UNITED STATES  
NUCLEAR REGULATORY COMMISSION  
REGION II  
101 MARIETTA STREET, N.W.  
ATLANTA, GEORGIA 30323

Report Nos.: 50-400/89-16

Facility Name: Harris 1

Inspection Conducted: July 31 - August 4, and August 14-18, 1989

Figure 1

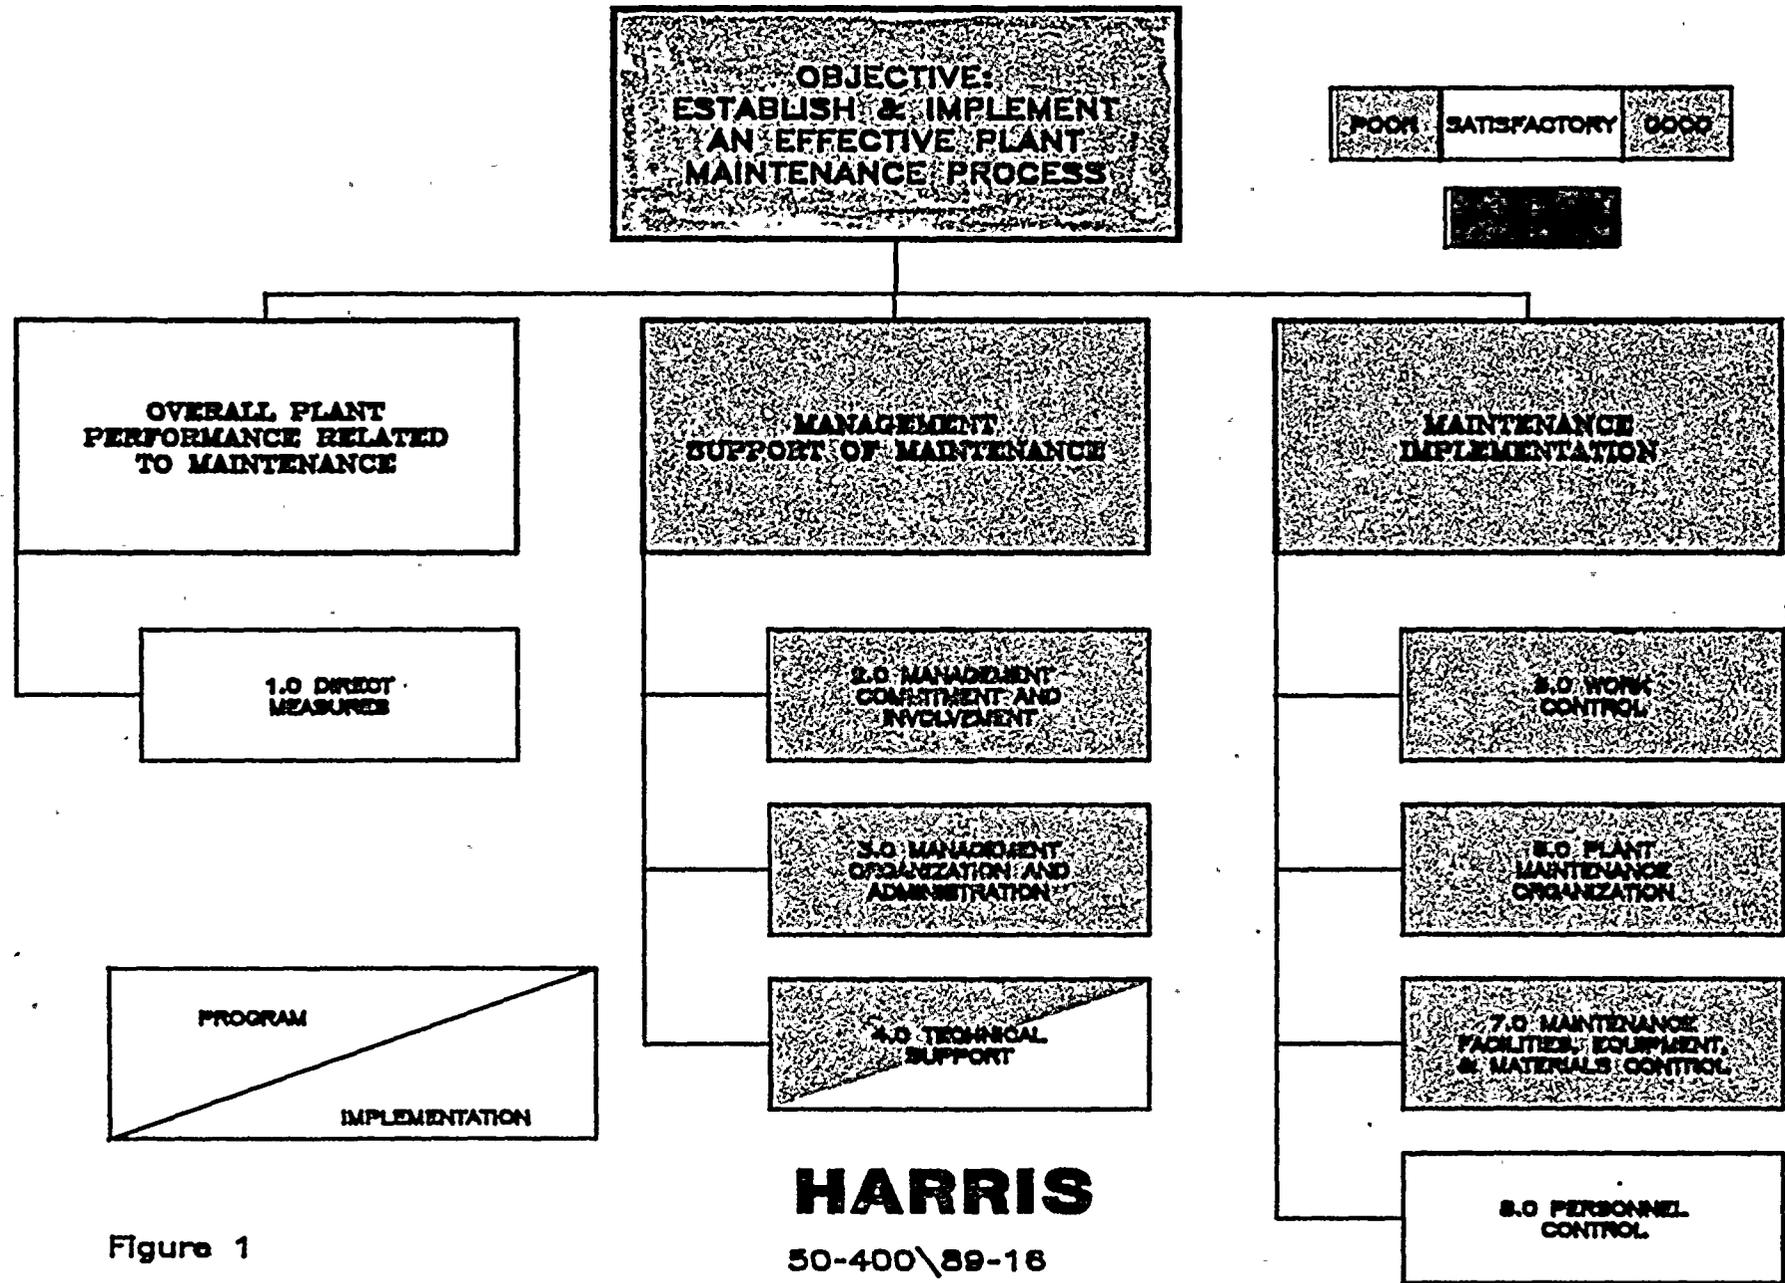
The inspection results are presented in Figure 1 as the completed inspection tree. As indicated in the tree, three major areas of the licensee's maintenance program were evaluated: (1) Overall Plant Performance Related to Maintenance, (2) Management Support of Maintenance, and (3) Maintenance Implementation. Under each major area, a number of elements were evaluated, rated, and colored in accordance with the following guidelines:

In general, the top half of the box (element) was rated depending on how well the element had been specified programmatically and the bottom half was rated depending on how well the element was being implemented. As noted in the tree, overall, the Harris program for establishing an effective maintenance program was rated GOOD. The implementation of the program was rated GOOD. For the three major areas; (1) Overall Plant Performance was rated SATISFACTORY, (2) Management Support was rated GOOD for program and GOOD for implementation, (3) Maintenance implementation was rated GOOD for program and GOOD for implementation. These ratings were based on specific strengths and weaknesses identified in the issues section of the report. The following are the more significant strengths and weaknesses identified (see report for details):
